GOODWILL INDUSTRIES

GRADING & DRAINAGE PLAN

**GOODWILL INDUSTRIES
GRADING AND DRAINAGE PLAN**

COVER PAGE

GRADING AND DRAINAGE
DITCH MODIFICATIONS

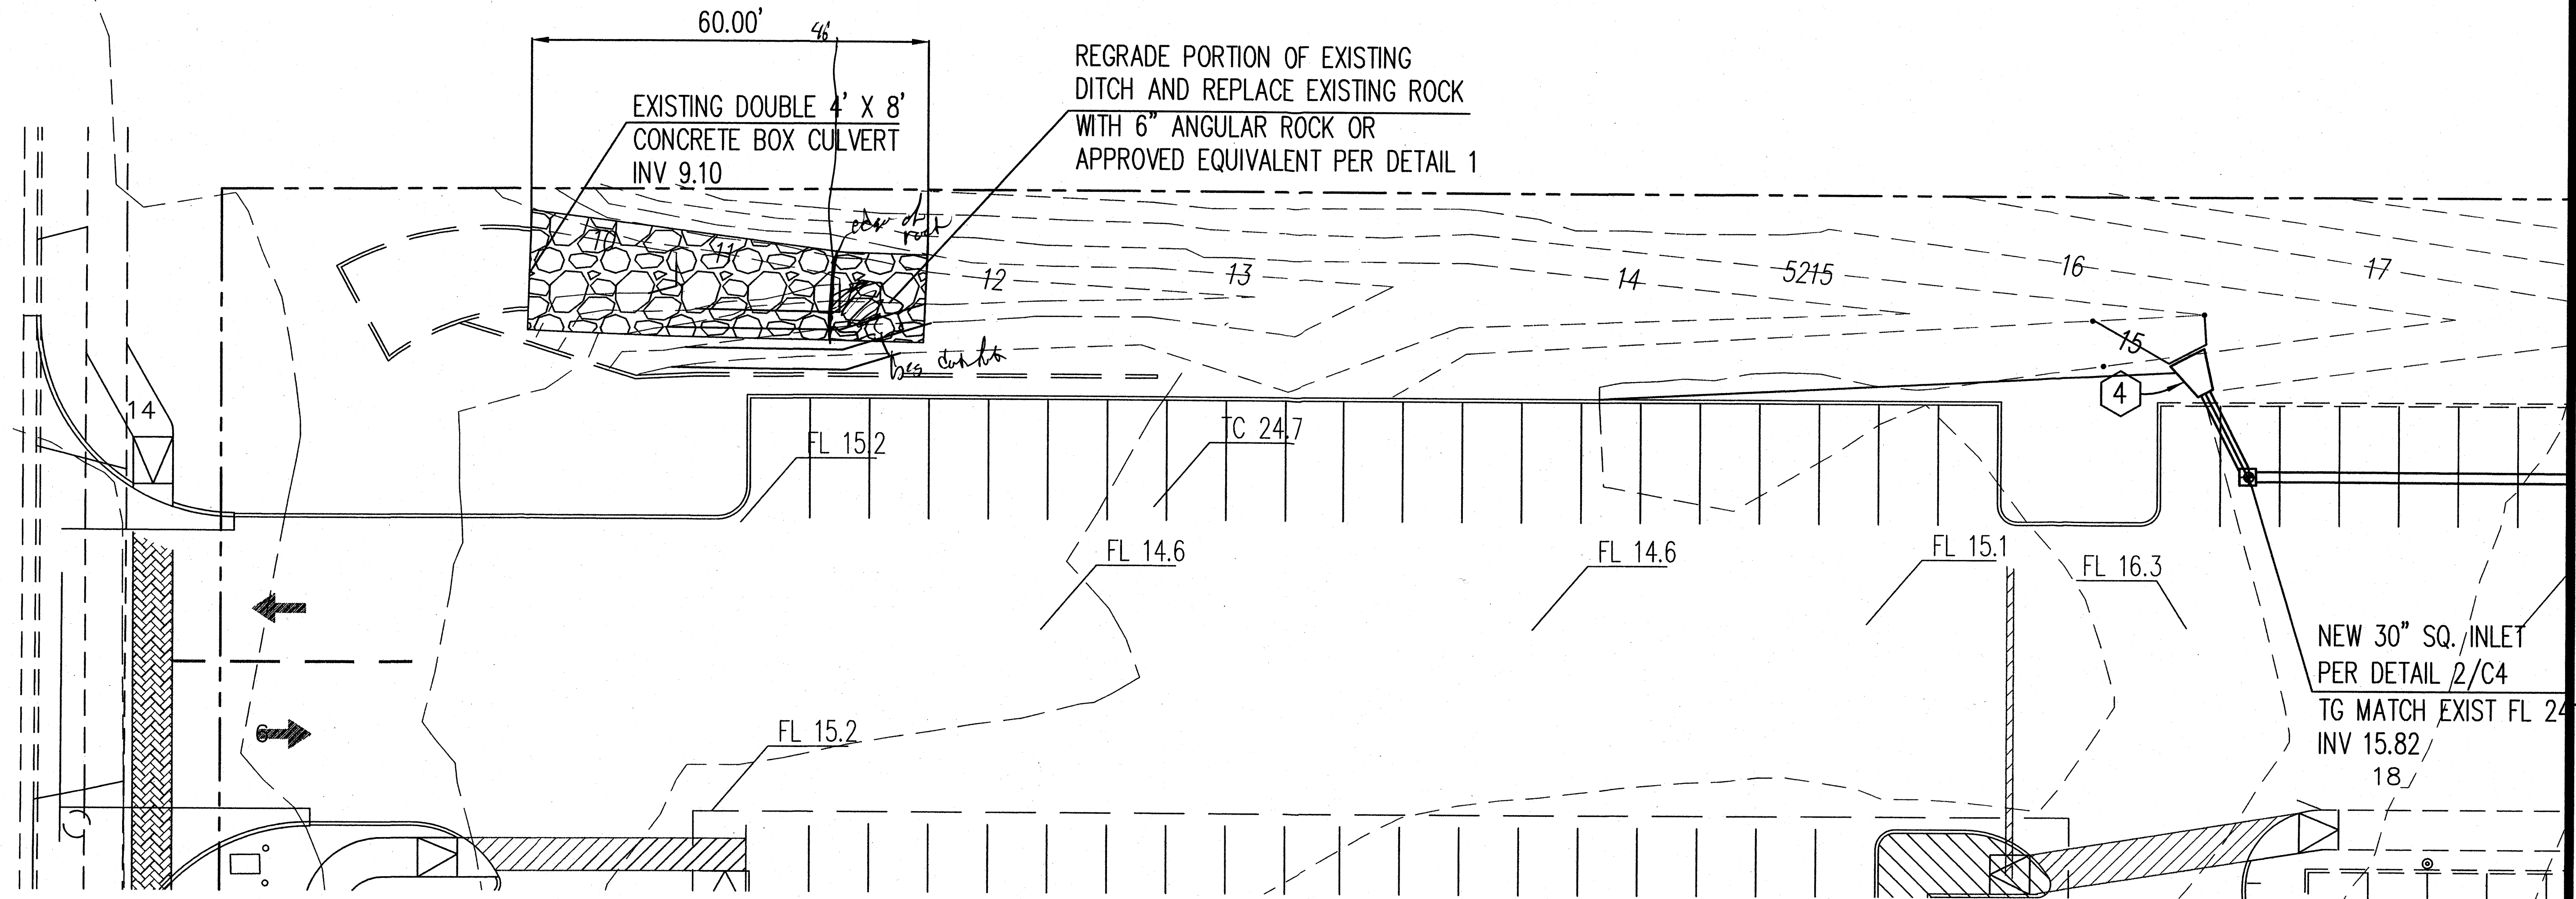
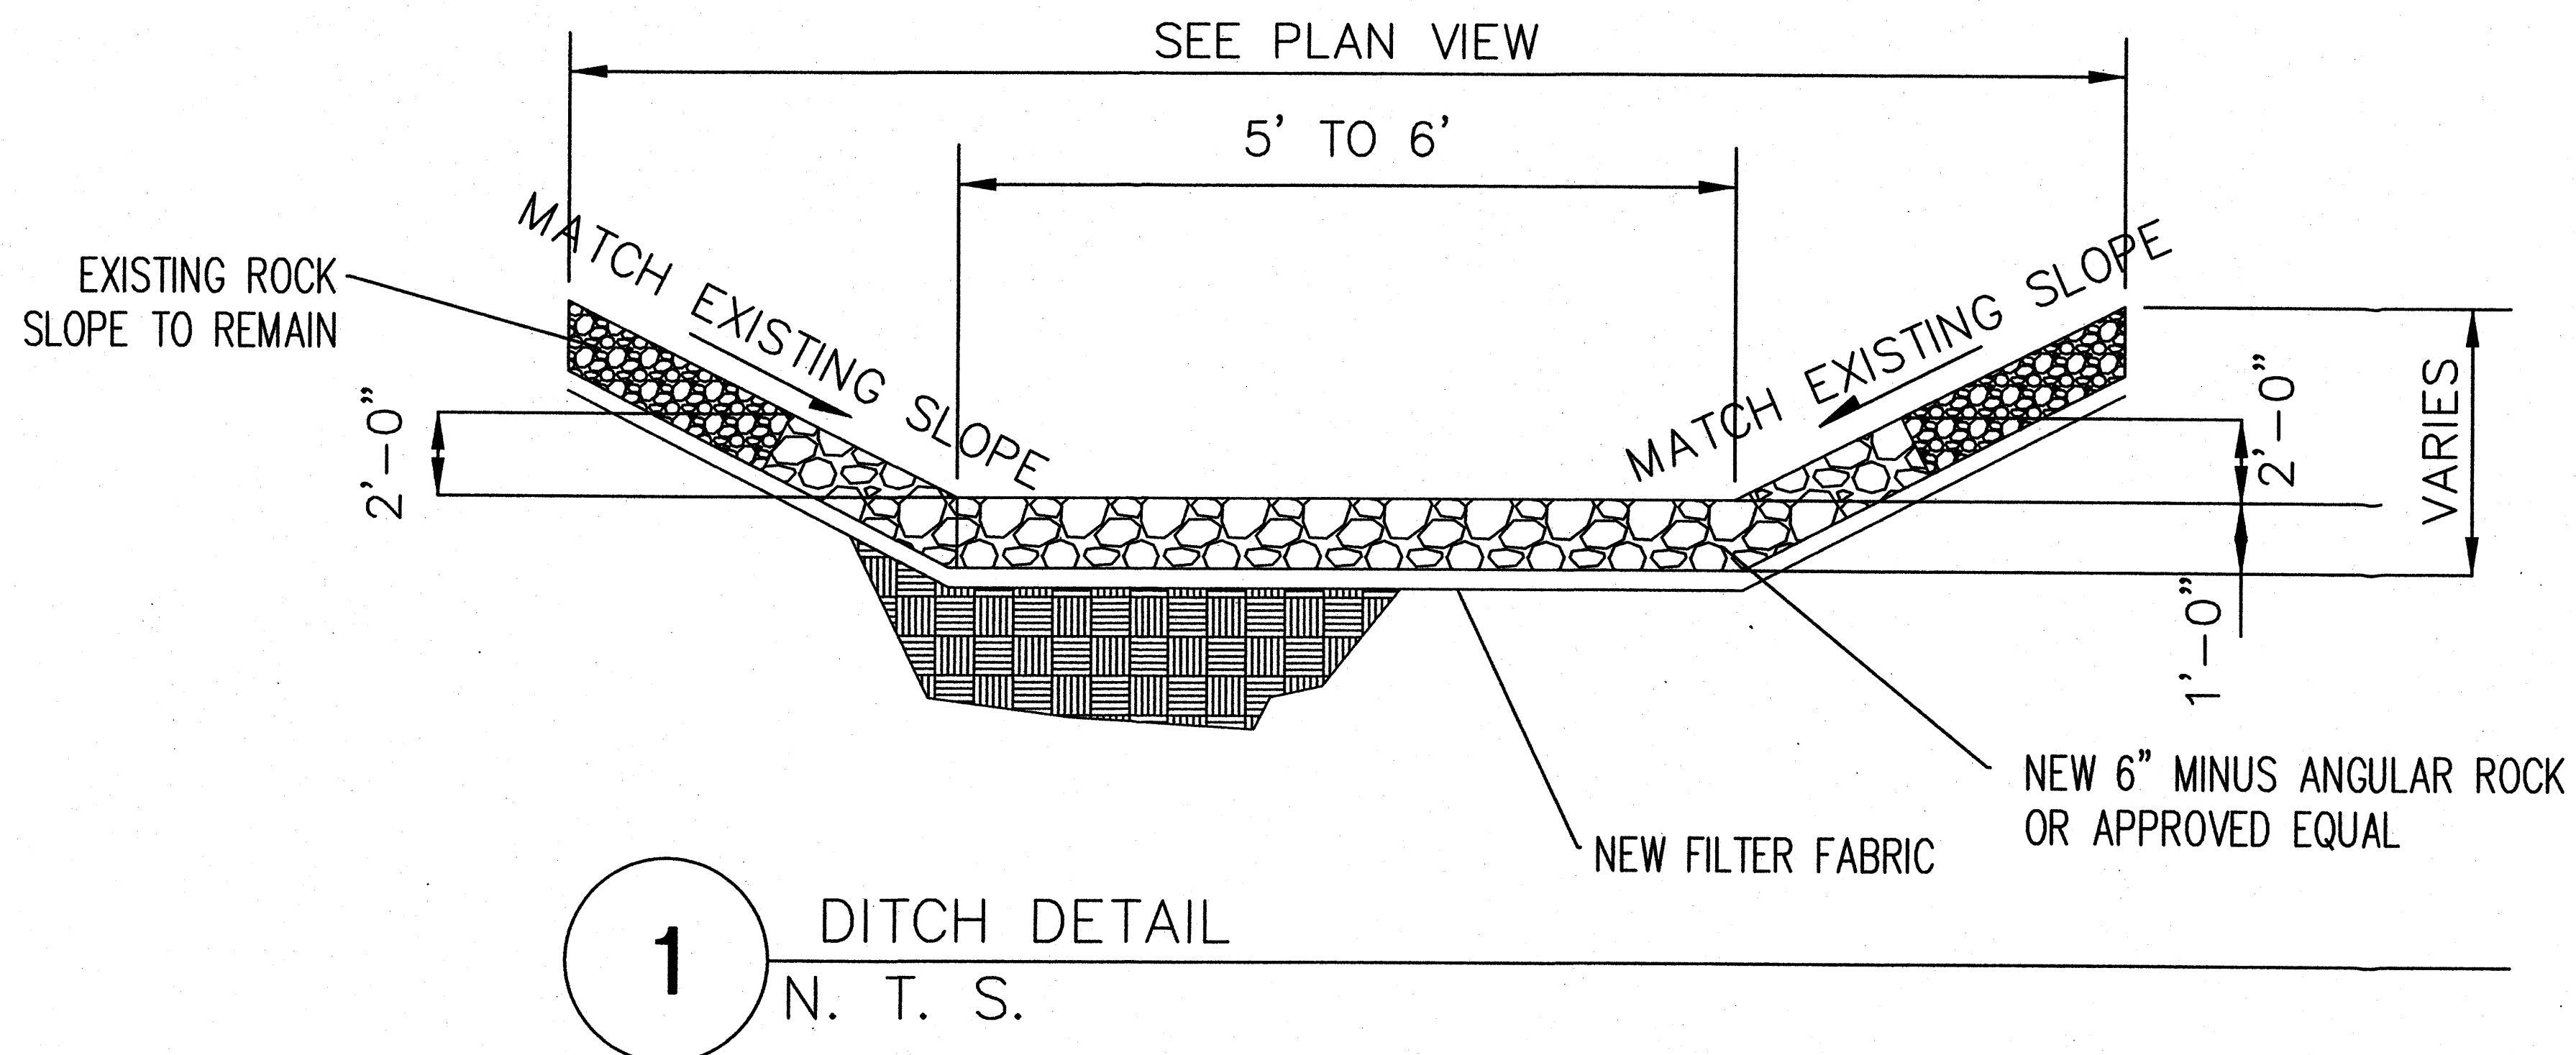
Exceptions: Changes have been edited onto the grading plan and noted. The major change was the addition of 3 - 18" sidewalk culverts in the dock surface to convey roof drainage from the roof drain downspouts, across the dock surface, to the edge of the dock to avoid slick areas and possible ice build-up.

Proposed Site Plan

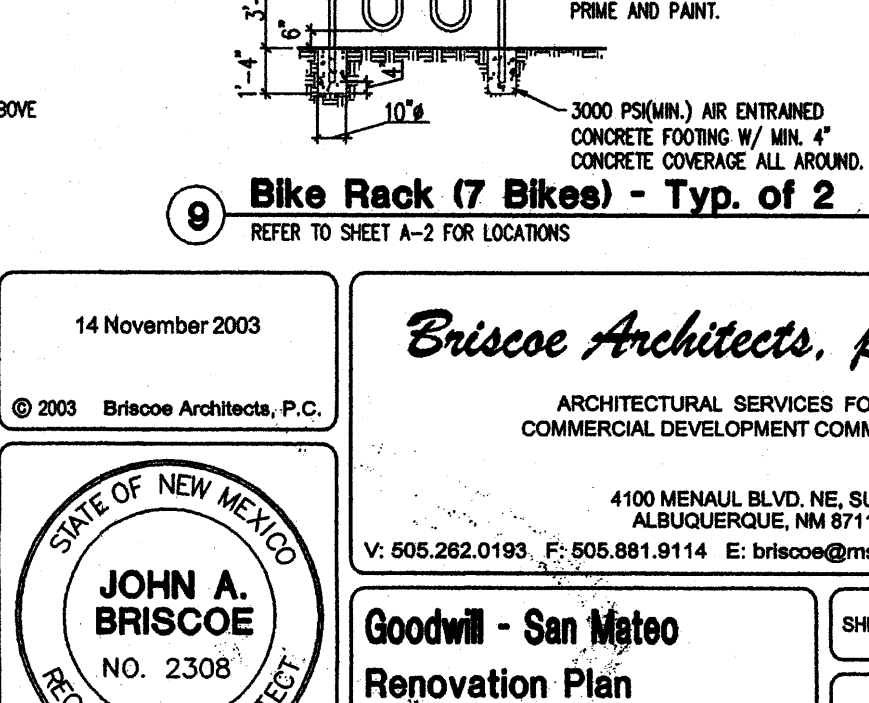
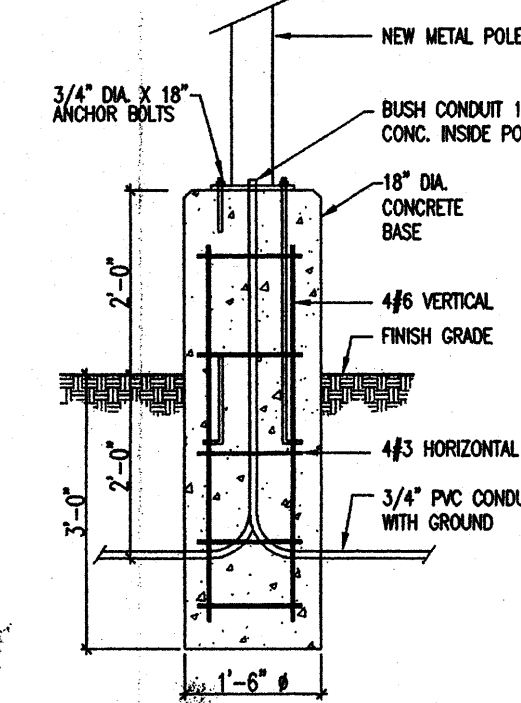
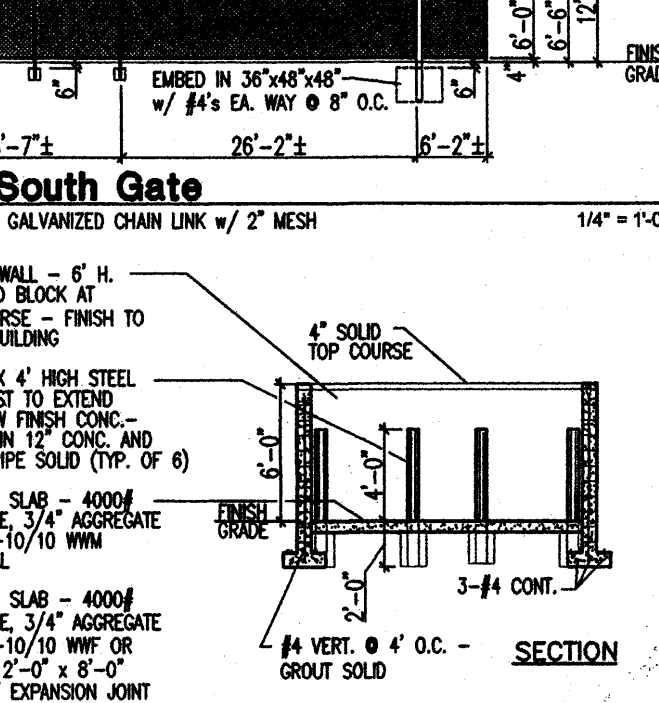
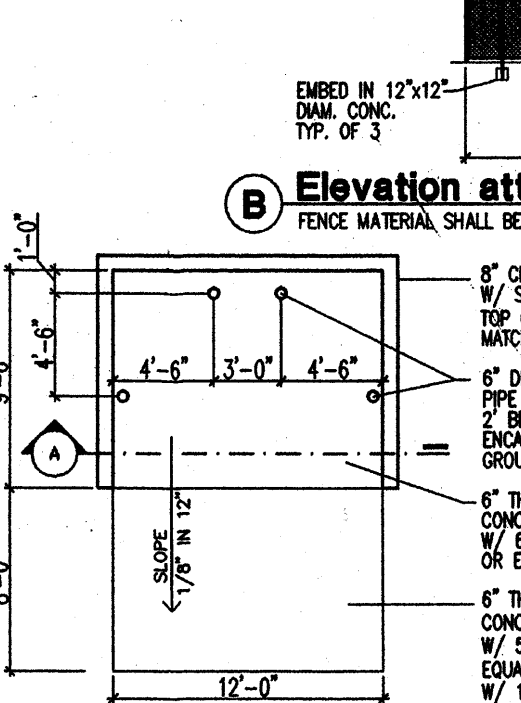
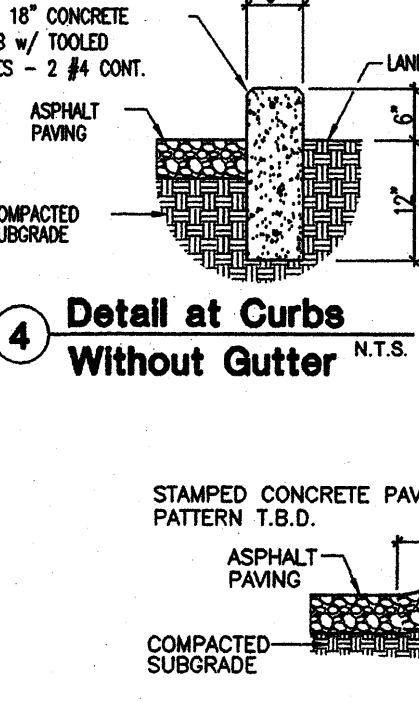
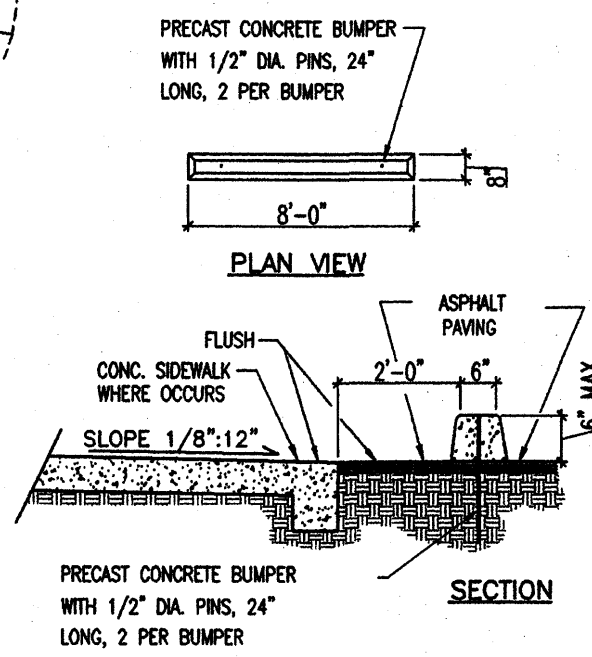
CHANNEL REPAIR PER HYDROLOGY REVIEW

12" HEADER WALL
FOR OFFSITE DRAINAGE PROTECTION
